City of Santa Barbara
Planning Division

Memorandum

SUBJECT: Staff Evaluation of proposed alterations

ADDRESS: 520 Plaza Rubio, Structure of Merit, Mills Act Project

Original 1951 drawing of front elevation

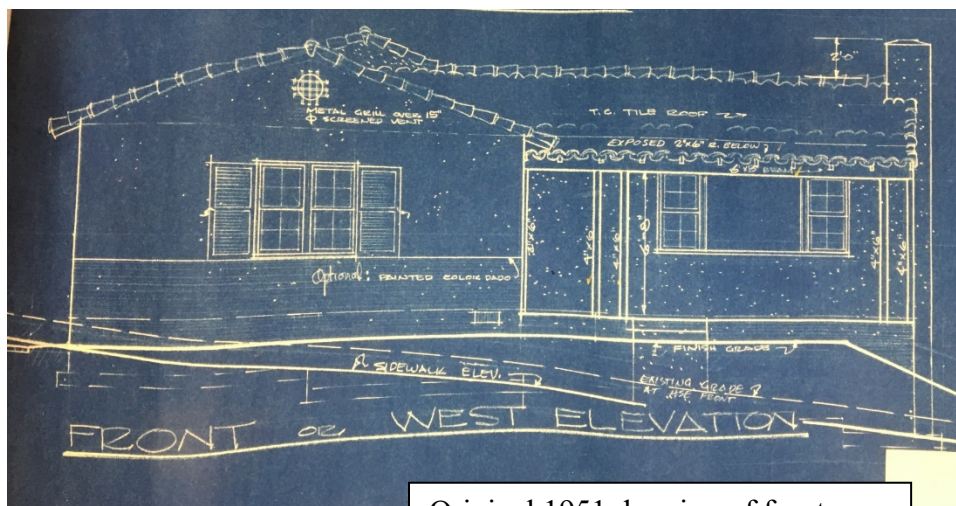
The original design had shutters flanking the windows that are not on the building today, which currently has a wrought iron "reyas" and heavy trim that were added some point after construction, date unknown. The proposed addition of the wrought iron Juliette balcony that extends 10" from the wall is a typical feature of the Spanish Colonial Revival and it has simple design that will not be overstated, and it will not look like an original element of the house and will not be a conjectural feature.
